Work Order ID 57504

Item Name: Basket Hoop

DRAWING NO. D3166	TITLE BASKET HOOP	REV A1	DART AEROSPACE LTD ENGINEERING ORDER		D.E.O. NO. D3166-A-2	SHEET NO. 1 OF 1	SCALE NTS
DRAWN AJS	CHECKED [Signature]	MFG. APPR. [Signature]	APPROVED [Signature]		DE APPR. [Signature]		
DATE 08.12.11	DATE 08.12.15	DATE 08/12/15	DATE 08/12/16		DATE 08.12.16

D3166-1 BASKET HOOP

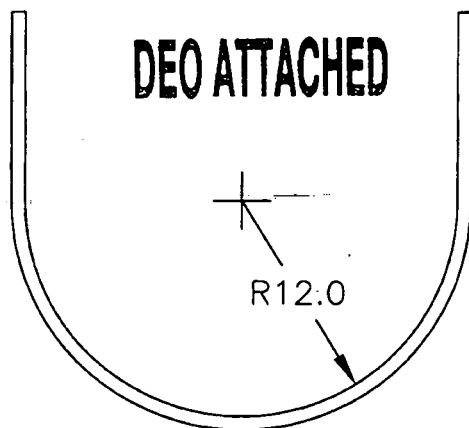
1) MODIFY MATERIAL NOTE FOR D3166-1 AS SHOWN:

WAS:

1) MATERIAL: AISI 304/316 SS SQUARE TUBING,
0.75" x 0.75" x 0.063 WALL, 60.00" LONG
(REF DART SPEC. M304TS0.750W.063)

IS:

1) MATERIAL: AISI 304/316 SS, 3/4 X 3/4 X 0.065 WALL SQUARE TUBING,
60.00" LONG
REF. DART SPEC M304TS0.750W.065

D3166-3 BASKET HOOP

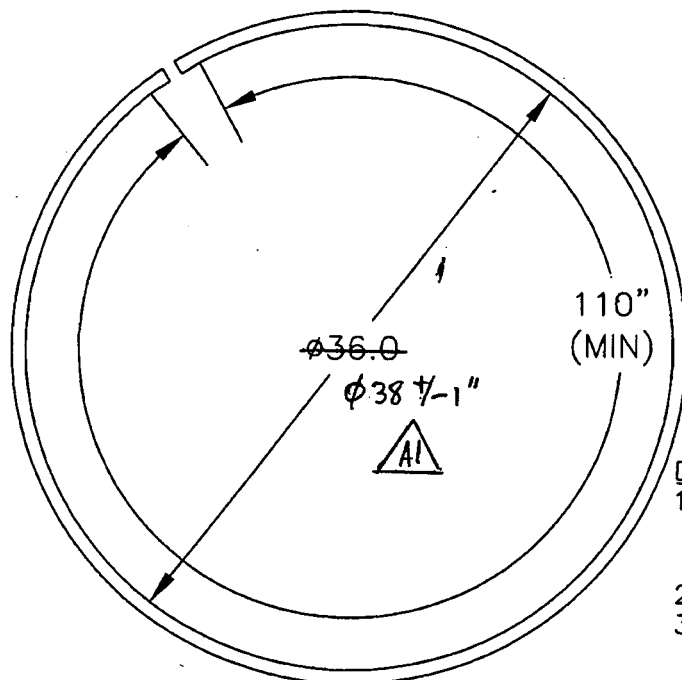
2) MODIFY MATERIAL NOTE FOR D3166-3 AS SHOWN:

WAS:

1) MATERIAL: AISI 304/316 SS SQUARE TUBING,
0.75" x 0.75" x 0.063 WALL, 120.00" LONG
(REF DART SPEC. M304TS0.750W.063)

REASON: SEE PAR 08-005

IS:

1) MATERIAL: AISI 304/316 SS, 3/4 X 3/4 X 0.065 WALL SQUARE TUBING,
120.00" LONG
REF. DART SPEC M304TS0.750W.065
